**Subject: Responses to Colorado Department of Health (CDH) and US Environmental Protection Agency (EPA) Comments on the OU4 Draft Final Phase II RFI/RI Work Plan**  
Operable Unit 4 Phase II RFI/RI Requirements Post Closure Assessment  
Task Order MTS 343780GG3 Under Master Task Subcontract MTS 225453RR

**RESPONSES TO COMMENTS  
PHASE II RFI/RI WORK PLAN  
Solar Evaporation Ponds, Operable Unit No. 4**

Figure 3.3-17  
OU4 Phase II Work Plan  
Trilinear Diagram Including Low TDS  
Samples from UHSU

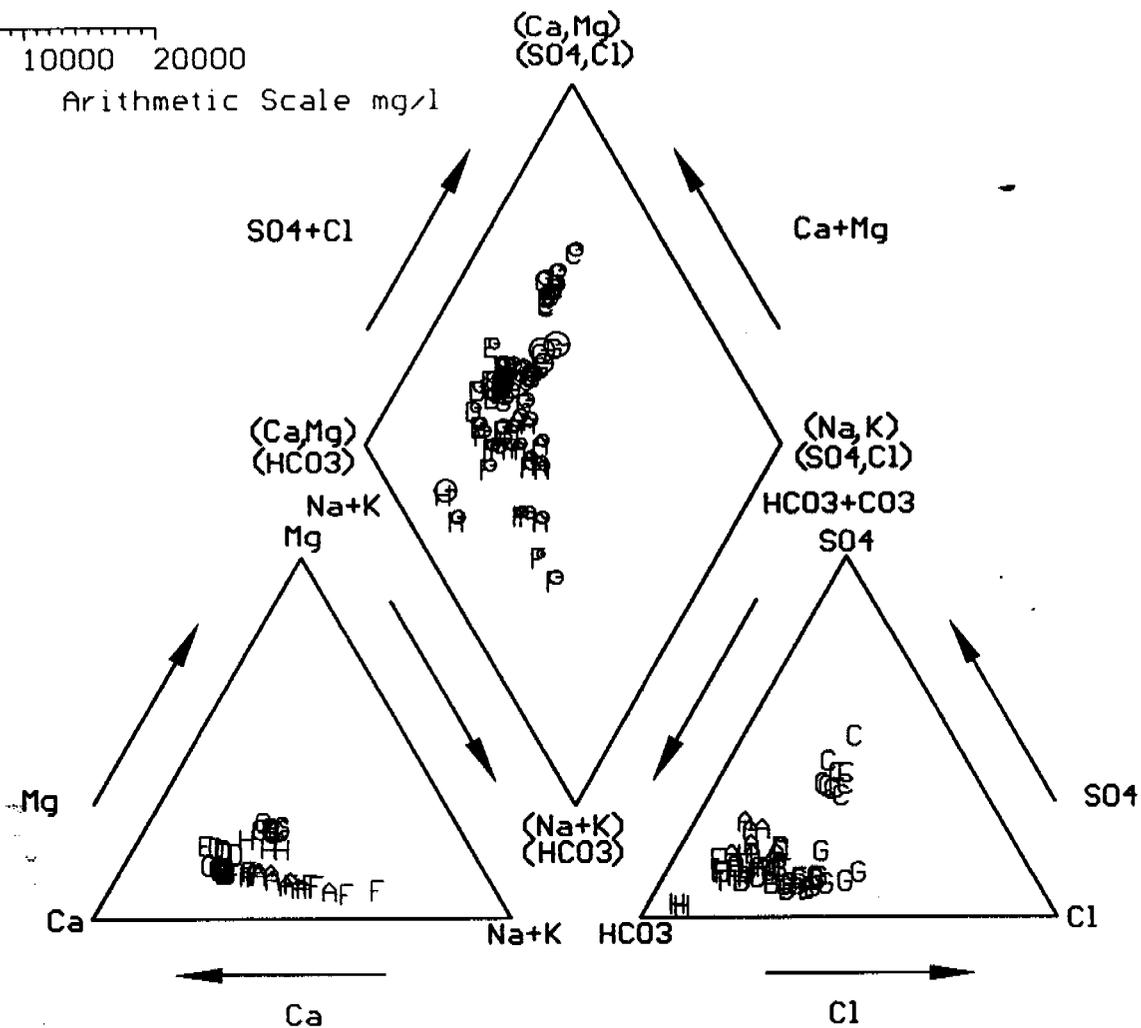
Pages 3-53 and 3-54 (Figures 3.3-17 and 3.3-18) were missing from the EPA copy of the OU4 Phase II RFI/RI Work Plan. These missing pages made it difficult to conduct a complete and coherent review of this section of the work plan.

*Figures 3.3-17 and 3.3-18 were inadvertently omitted from the Draft Final Work Plan during reproduction. The figures are attached and will be provided in the Final Phase II RFI/RI Work Plan.*

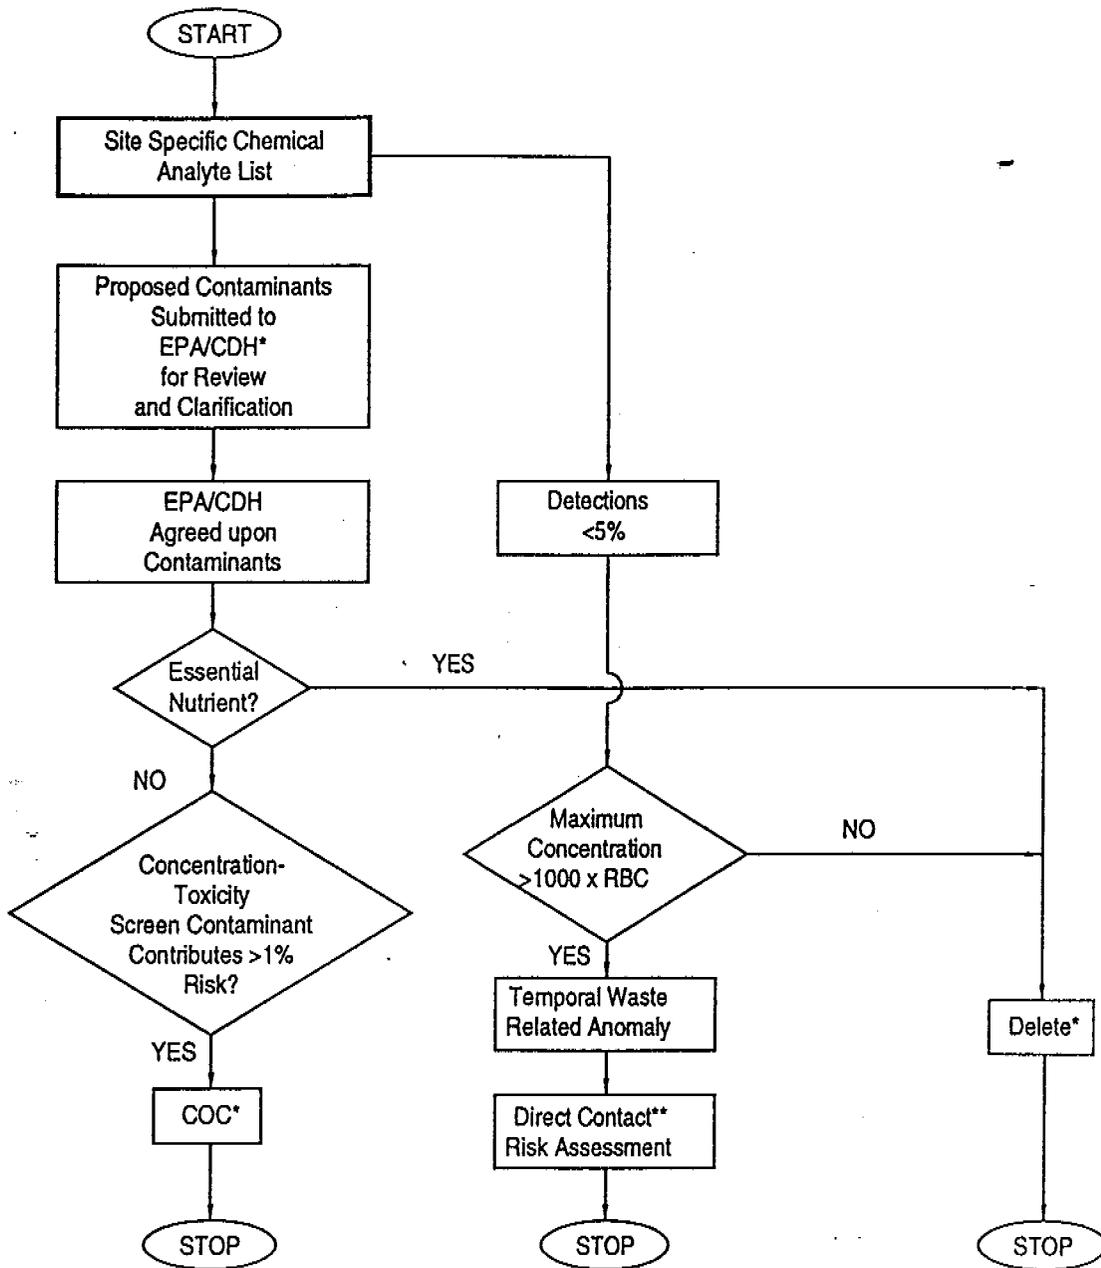
Section 7, Page 7-6, Second Set of Bullets. This section describes comparison of site contaminants to background levels. The description is incomplete. It should also describe how hot spots will be identified in the data evaluation analysis.

*The attached flow chart elaborates on the discussion of comparison of site contaminants to background, which is mentioned at the end of Section 7.1.3.1. This flow chart explains the COC selection process. A description of the identification of hotspots, or areas of high contamination relative to other areas of the site, will be added to this data evaluation section.*
